DATE: January 14, 2002  
PROJ. #: DG92960H.4CT1  
SUBJECT: Former Chevron Station #9-2960  
2416 Grove Way  
Castro Valley, California

**Subject: Work Plan Addendum #2 for Monitoring Well Installation and Soil Boring**  
Former Chevron Station #9-2960  
2416 Grove Way, Castro Valley, CA  
DG92960H.4CT1

**SITE PLAN**  
 Former Chevron Service Station No. 9-2960  
 2416 Grove Way  
 Castro Valley, California

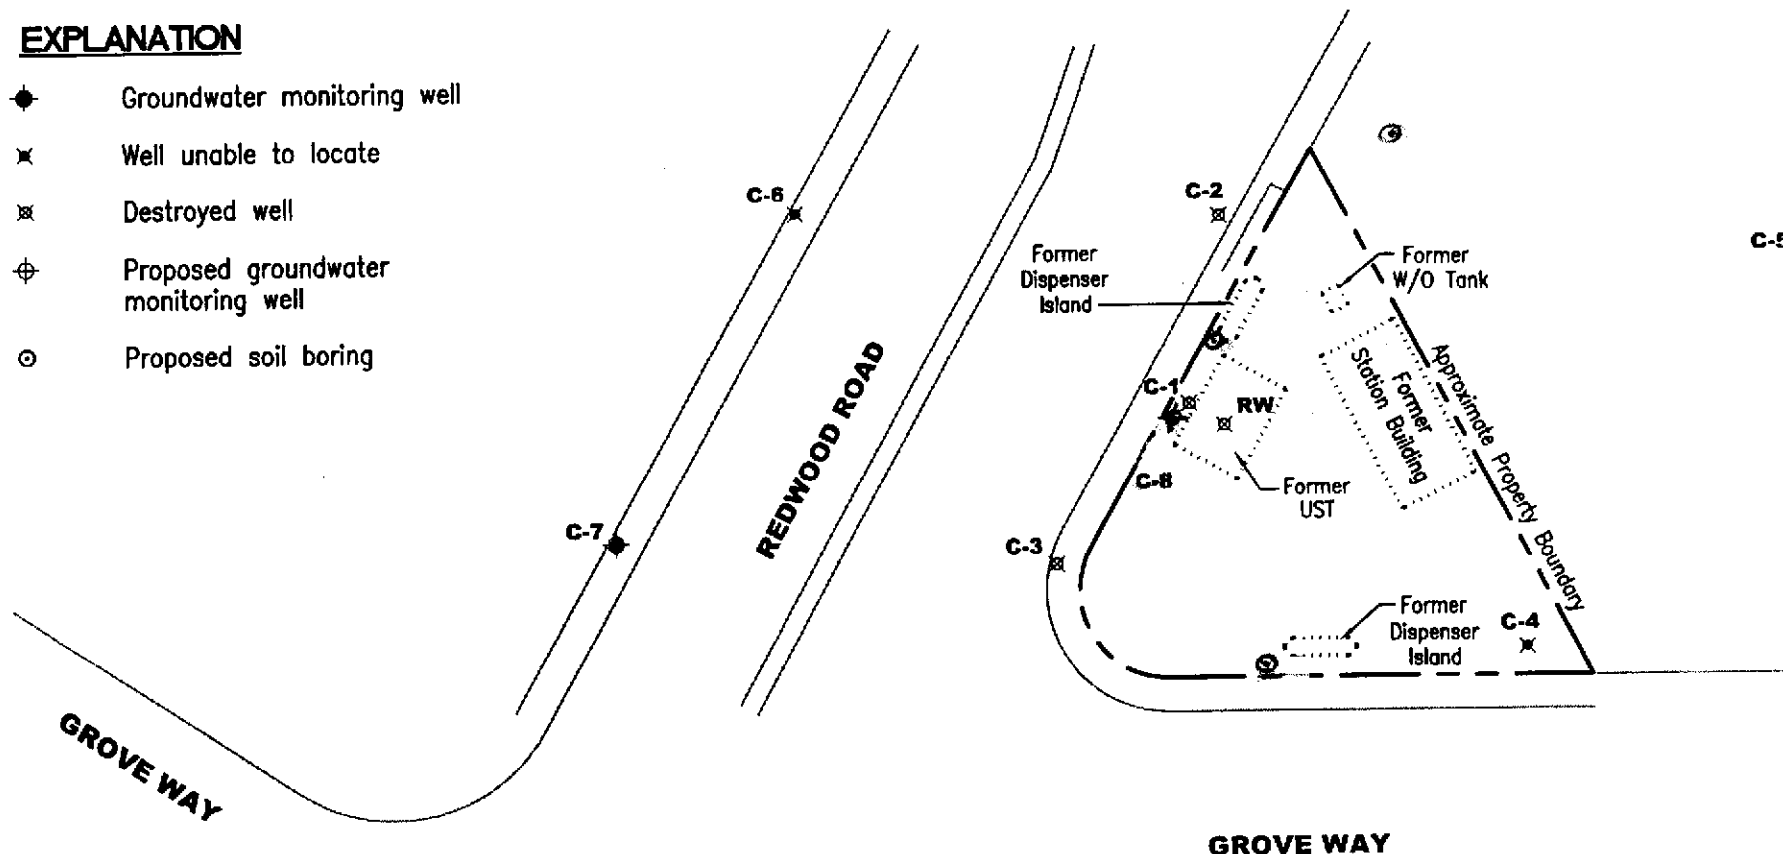
- In an effort to evaluate the dissolved hydrocarbon plume in the area of the former UST complex, dispenser islands, and near former groundwater monitoring wells C-1 and C-2; GR proposes moving groundwater monitoring well C-8 southwest (downgradient) of former well C-1,
- GR proposes to advance one soil boring to groundwater and collect a grab groundwater sample at a location between former wells C-1 and C-2 as presented in Figure 2, and
- Finally, GR proposes two soil borings to groundwater and collection of grab groundwater samples at locations north of the property boundary (upgradient of former well C-2) and southwest (downgradient) of the former dispenser island located near Grove Way.

**SITE PLAN**  
 Former Chevron Service Station No. 9-2960  
 2416 Grove Way  
 Castro Valley, California

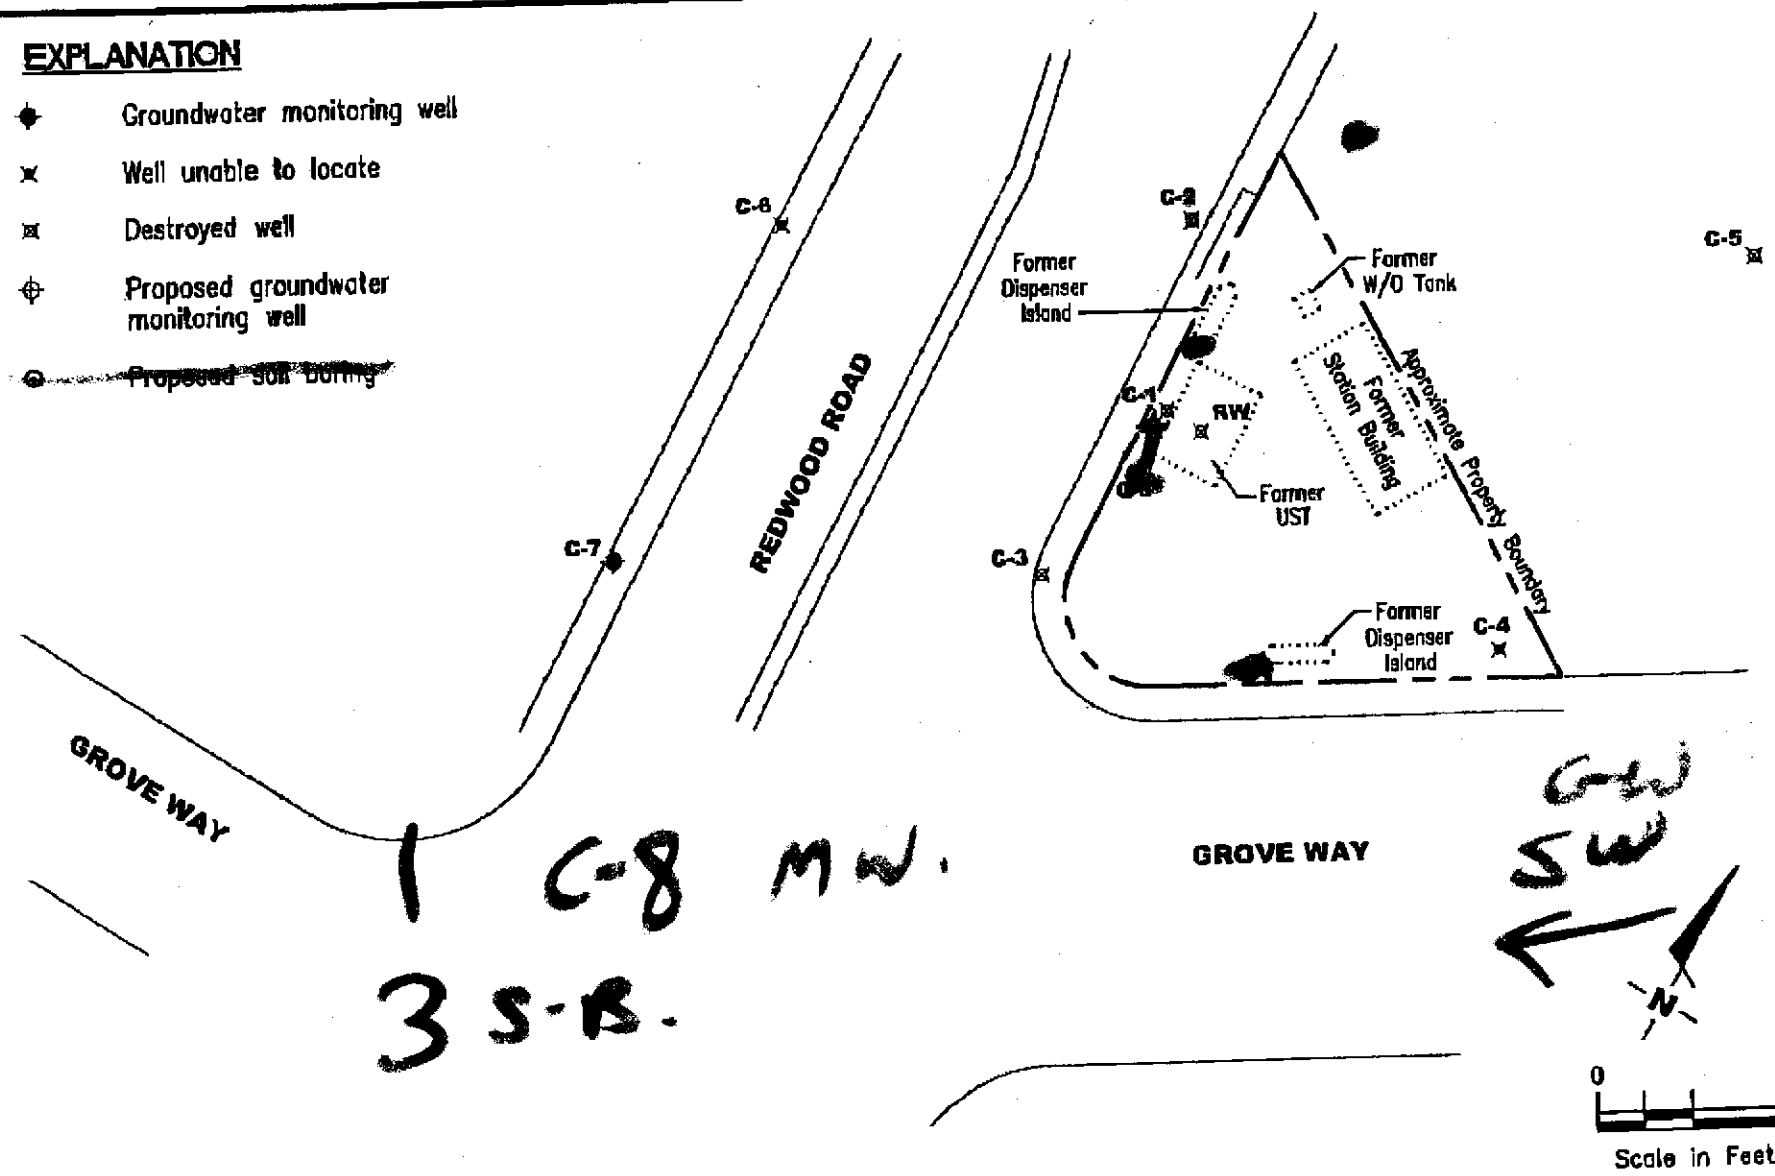
- In an effort to evaluate the dissolved hydrocarbon plume in the area of the former UST complex, dispenser islands, and near former groundwater monitoring wells C-1 and C-2; GR proposes moving groundwater monitoring well C-8 southwest (downgradient) of former well C-1.
- GR proposes to advance one soil boring to groundwater and collect a grab groundwater sample at a location between former wells C-1 and C-2 as presented in Figure 2, and
- Finally, GR proposes two soil borings to groundwater and collection of grab groundwater samples at locations north of the property boundary (upgradient of former well C-2) and southwest (downgradient) of the former dispenser island located near Grove Way.
